Overview: Production error in version 1.0 harnesses; The immobilizer wire (orange/black) is in pin position #4 instead of pin position #5. Although an effort to correct the issue was made, some quantity of harnesses did get shipped before the issue was spotted. We are advising to inspect the harness BLADE connector before attempting to install harness or program the module. This issue is not known to affect the version 2 harnesses, which require no modification.

Overview: Early versions of the FTI-STP1 harness require modification for **automatic transmission (AT)** applications, some of the product was able to be modified before release, but a small quantity was released without modification.

FTI-STP1: Vehicle Coverage and Preparation Notes

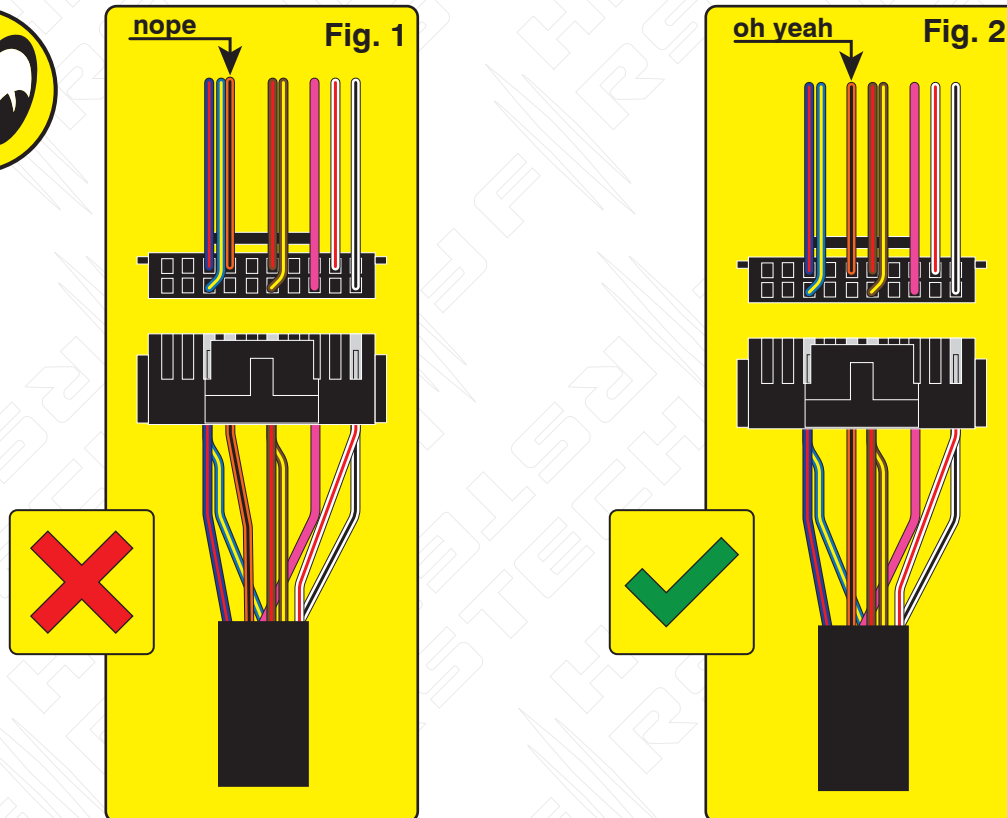
Issue: Module fails to program correctly to vehicle, does not allow the vehicle to be remote started.

Correction: Step 1.) Locate the orange/black wire and confirm whether it is positioned as illustrated in Fig. 1 or Fig. 2. If the wire is as illustrated in Fig.1, proceed with Step 2 through 5 and complete the repair procedure outlined, if the wire is as illustrated in Fig. 2, correction is not necessary, proceed with harness installation and module programming.

Step 2.) Using a pick, lightly depress the catch that secures the terminal in the housing then remove the wire and terminal from the housing.

Step 3.) Using a fine tip razor or utility knife, insert the blade beneath the terminal catch and raise it slightly, so that it can be reused to secure the terminal when reinserted into the BLADE connector housing.

Step 4.) Refer to Fig. 2 for correct position of the orange/black wire (next to brown/red) then reinsert the terminal, pressing lightly until the catch 'snaps' into place, securing the terminal in the connector housing.

MODIFICATION REQUIRED FOR A/T APPLICATIONS, ONLY WITH v 1.0 HARNESS

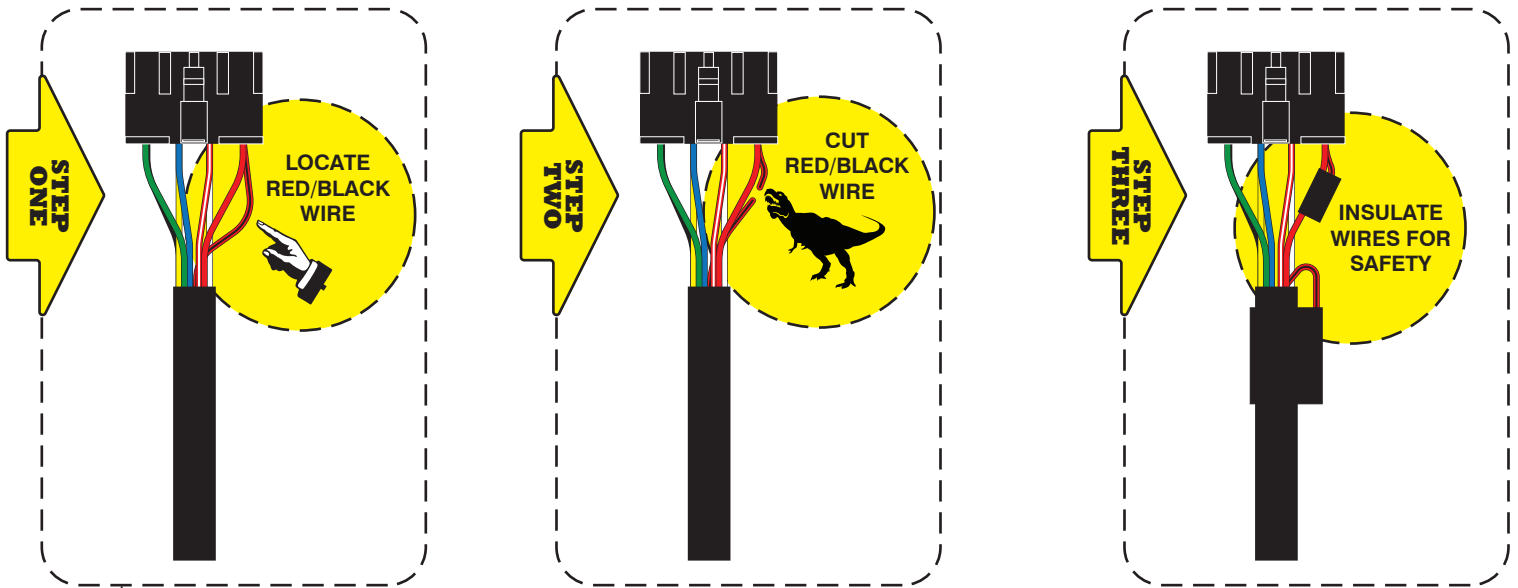
Issue: The FTI-STP1 T-harness has been designed to be compatible with A/T (automatic transmission) & M/T (manual transmission) applications, but due to an oversight in early production runs, the selection was defaulted to M/T mode.

Using a harness configured for an M/T application, in an A/T equipped vehicle, could result in vehicle module damage, it is advised that the harness be returned to A/T mode before installation in vehicles equipped with an automatic transmission.

Correction: Locate the **red/black (+ Clutch)** wire provided in the CN1 connector of the main harness assembly. Cut the **red/black** wire, either flush to the CN1 connector, or leaving enough wire exposed so that you can insulate and secure the ends of the wire that remain after cutting. Insulate each of the remaining ends of the **red/black** wire and secure to prevent any possibility of a short circuit. **If the red/black wire has already been disconnected, no further modification is required for A/T applications**

MODIFICATION NOT REQUIRED WHEN USING FTI-STP1 (v 1.0) HARNESS IN M/T APPLICATIONS, OR WHEN USING THE FTI-STP1 (v 2.0) HARNESS

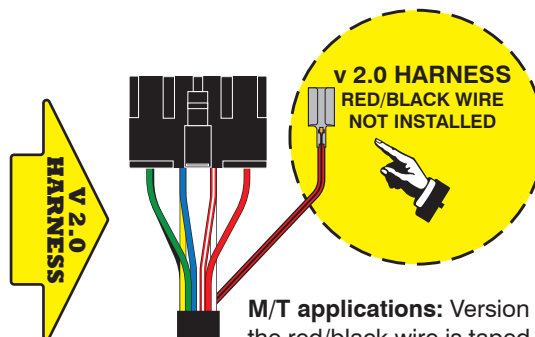
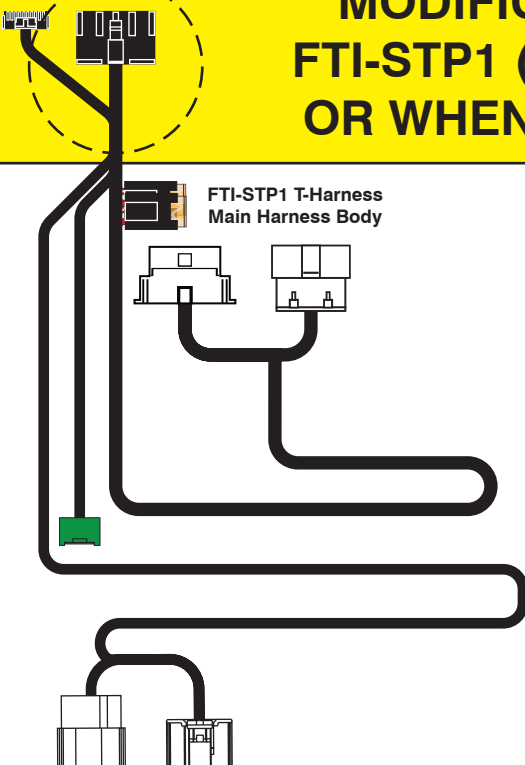
M/T applications: Version 2.0 harness, the red/black wire is taped to the main harness when shipped, and must be installed in the CN1 connector when installed.

A/T applications: Leave the red/black wire taped to the harness, it is not required for A/T applications
